BID ADDENDUM NO.1

2181539 Bank on Buffalo, Niagara Falls, NY

There was an error during the printing process that caused the structural & HVAC items to not appear in the Architectural drawings. Some of the drawings being replaced are only to show the missing items for clarification. No actual changes are occurring on these sheets. Any changes to the drawings are clouded & tagged.

E-101

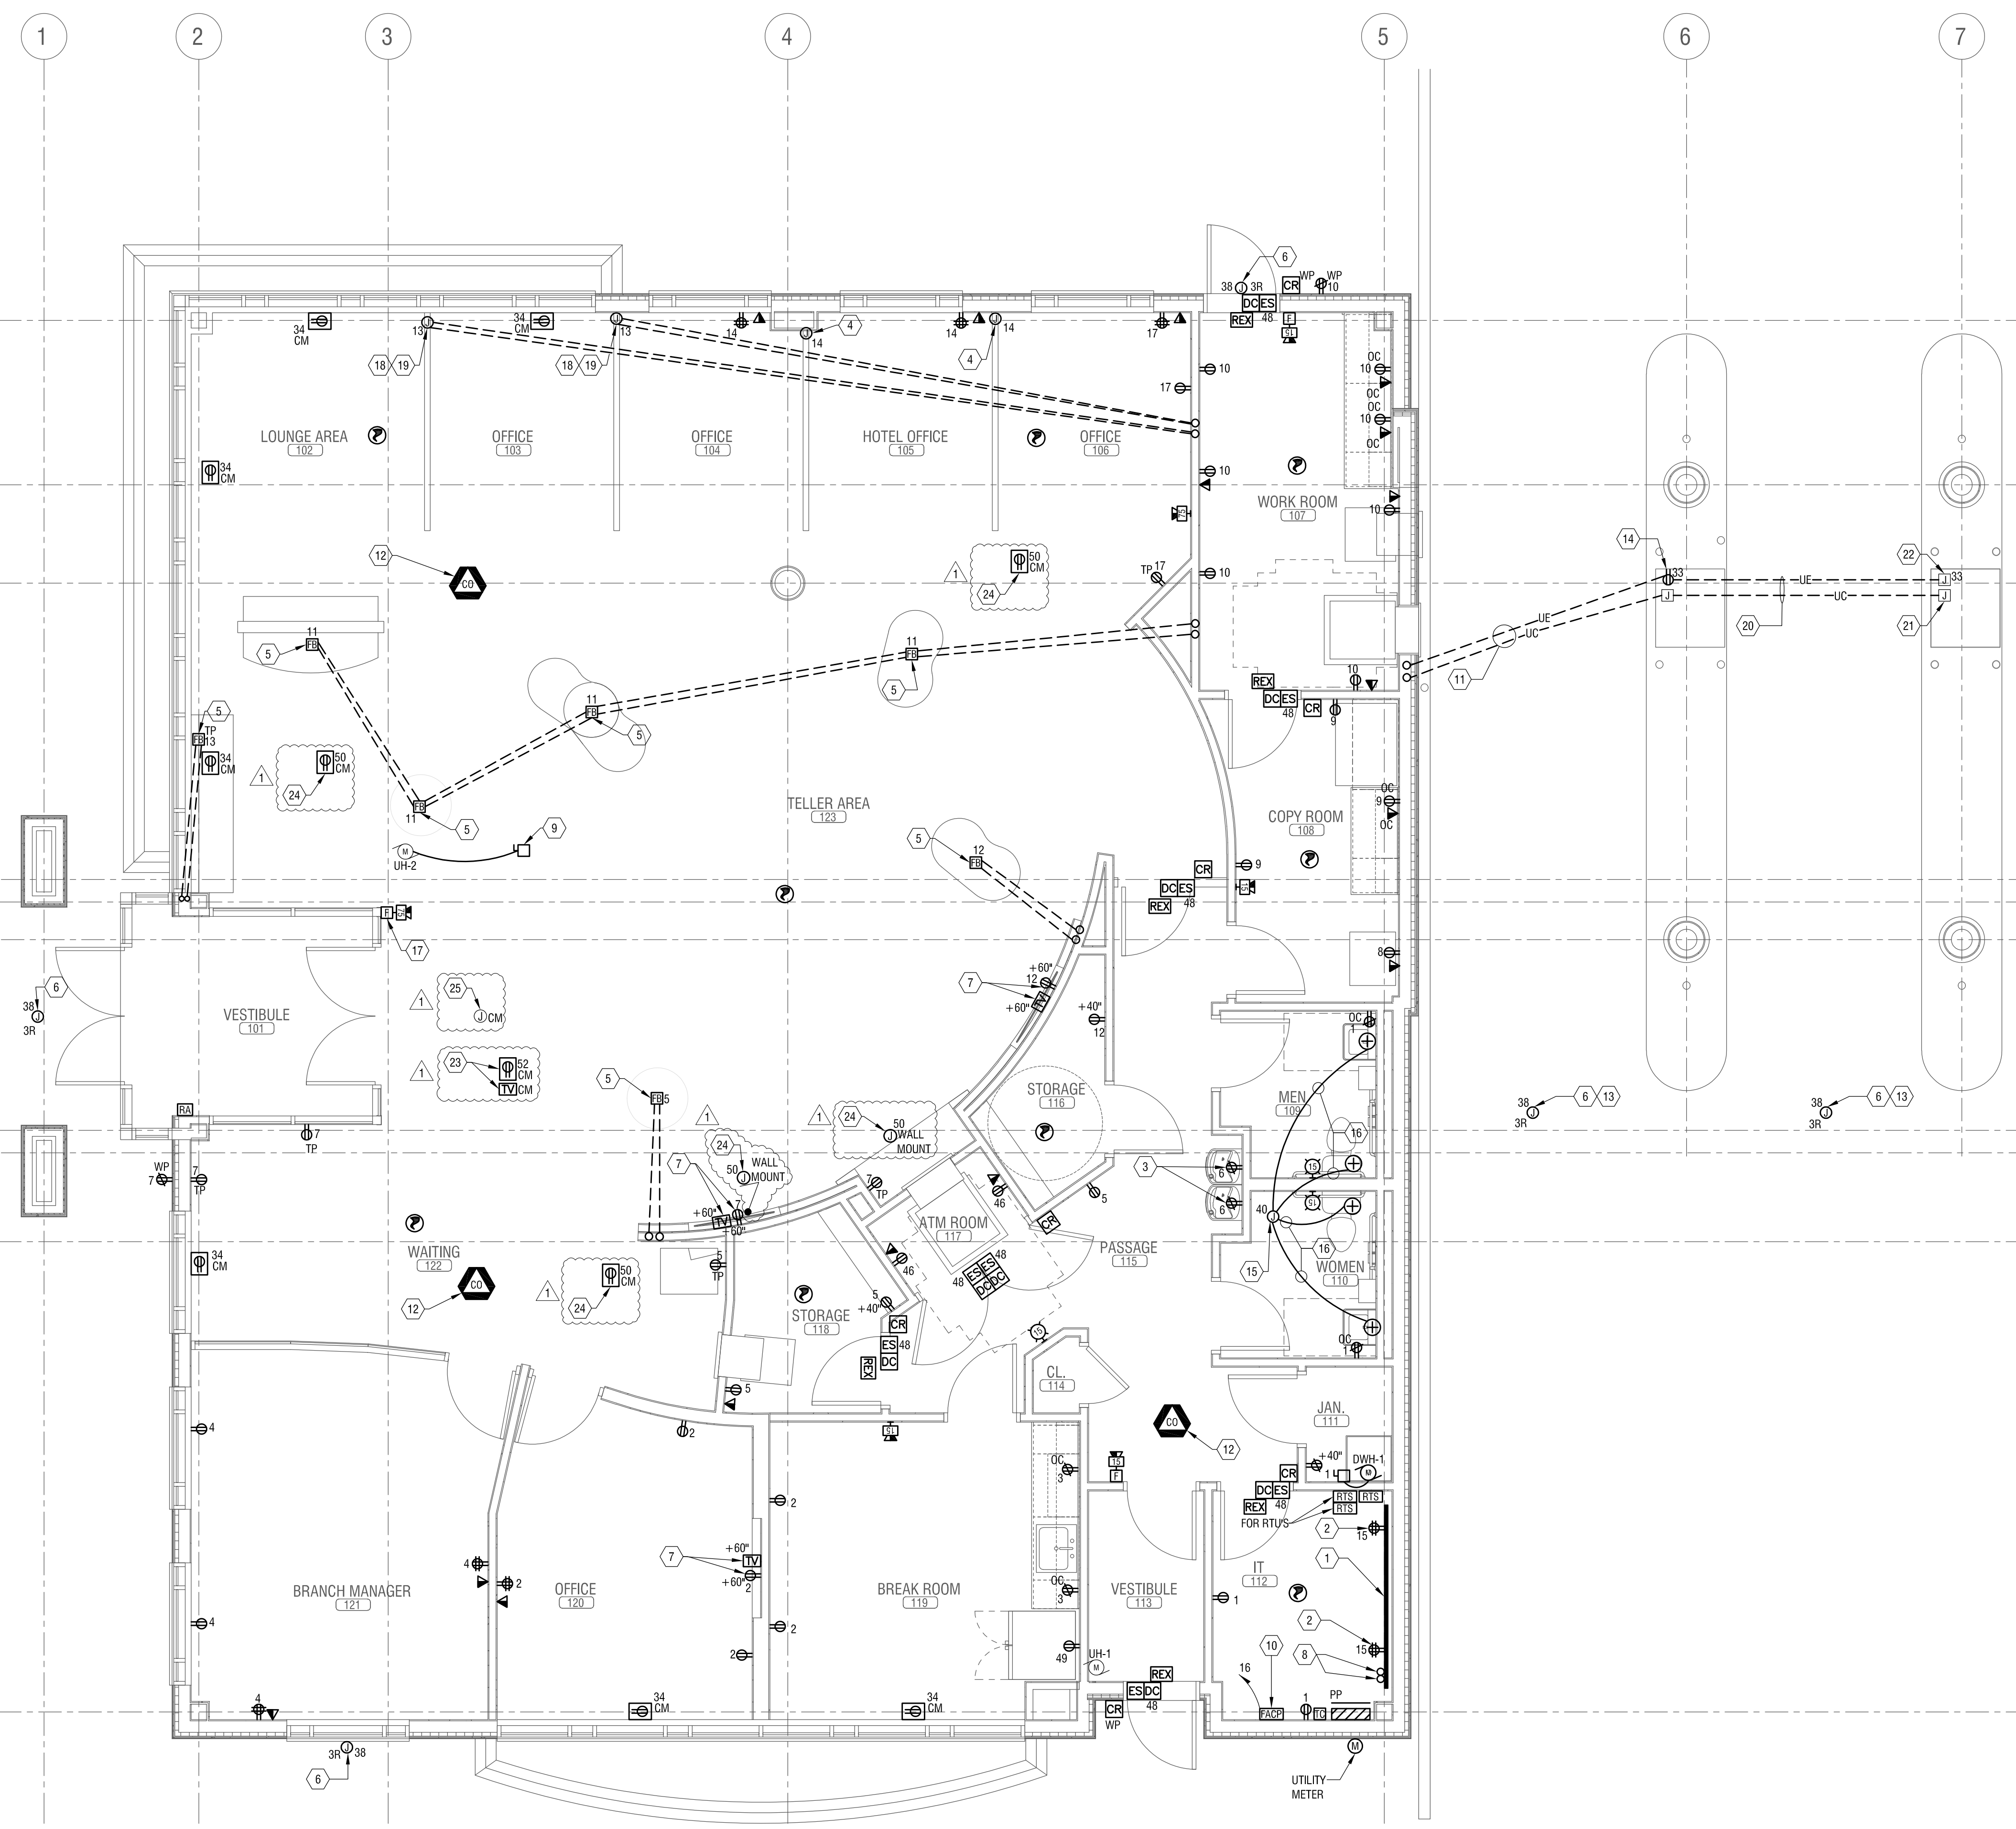
1. DELETE: This drawing in its entirety.
2. ADD replacement Drawing E101
3. Addition of (5) powered signs, ceiling hung TV, & camera

1 **TIMER CONTROL WIRING DIAGRAM (TC)**
E-502 NOT TO SCALE

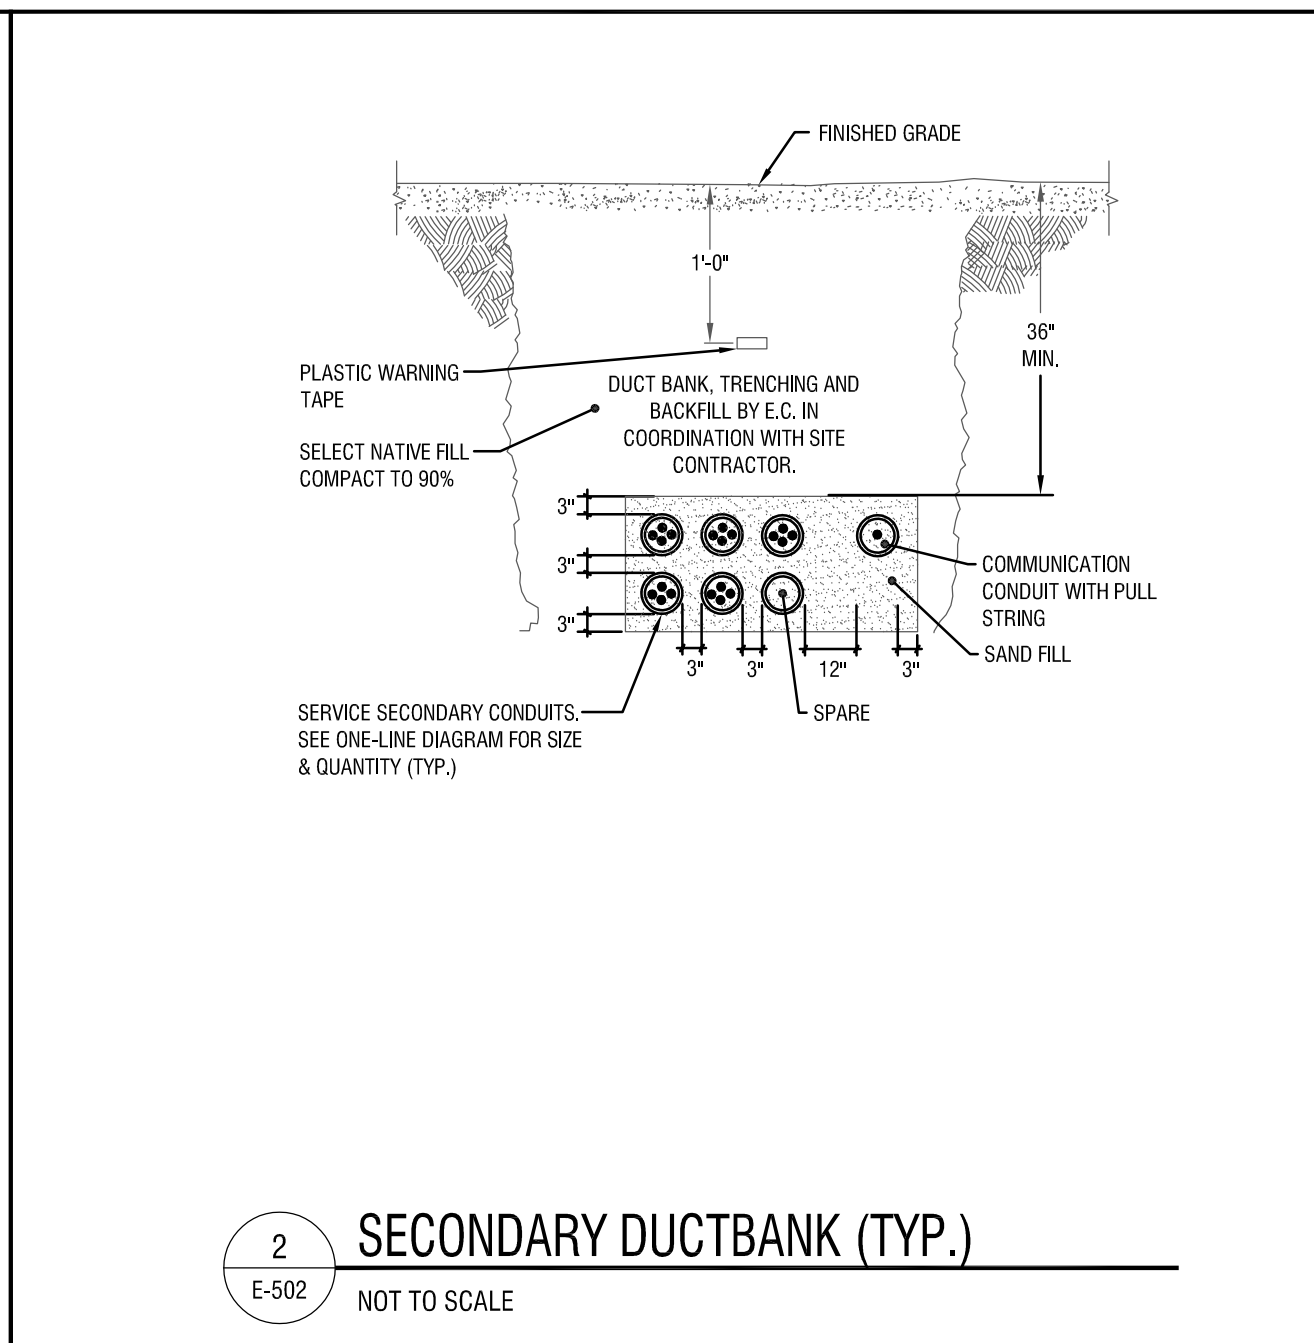
1. DELETE: This drawing in its entirety.
2. ADD replacement Drawing E502
3. Timer control changes
